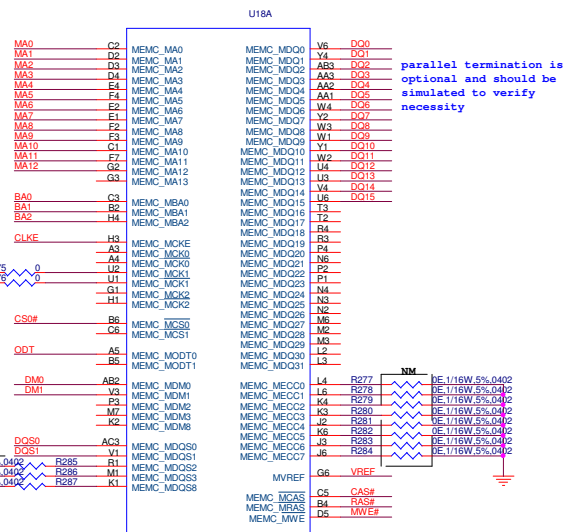
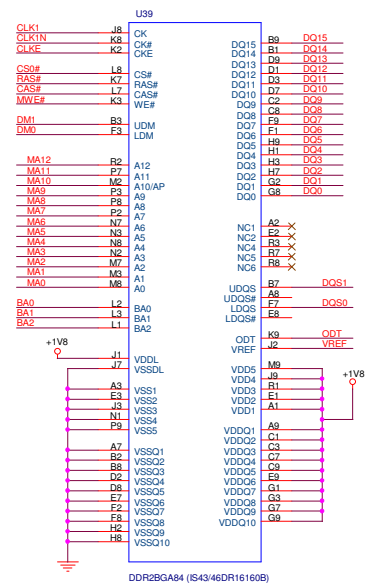
Check why CLK0 and CLK0# is not used instead CLK1 and CLK1#

parallel termination is optional and should be simulated to verify necessity

VREF (0.9V+/- 18mV)

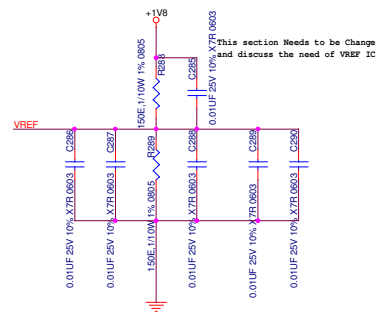
this section needs to be change and discuss the need of VREF ic
